DOCUMENT CHANGE REQUEST

DCR number	316	Changes required for:	N/A	Originator:	Olivier Masson Chief
Date:	2007/02/01	Date sent:	2007/02/01	Organisation:	CNES
Status:	IMPLEMENTED

Title: Contacts Power Crimp-Type and Solder Type for 3401/001 and 3401/002 Connectors

Number: 3401/040 Issue: 3

FIGURE 2(c) - PROTRUSION AND RECESS

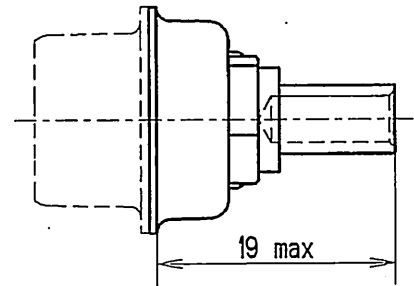
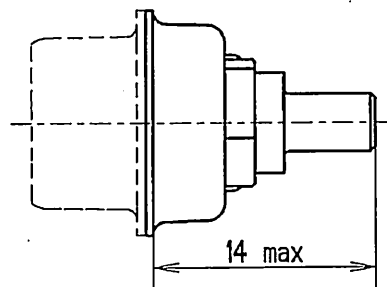
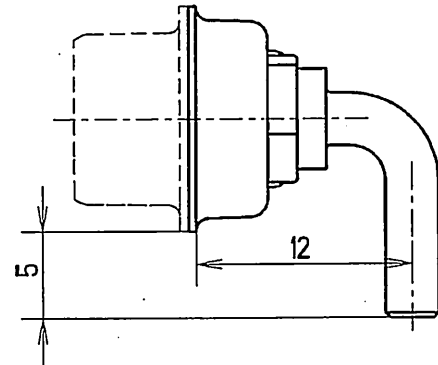
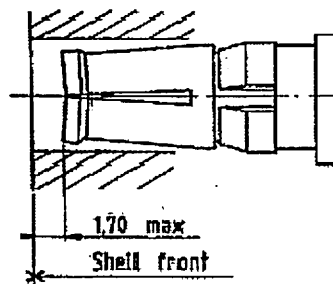
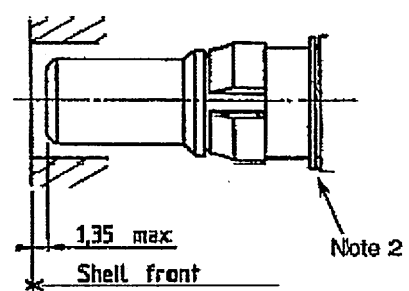
5) Page 10, Fig 2(c) should be renumbered: "FIGURE 2(d)"
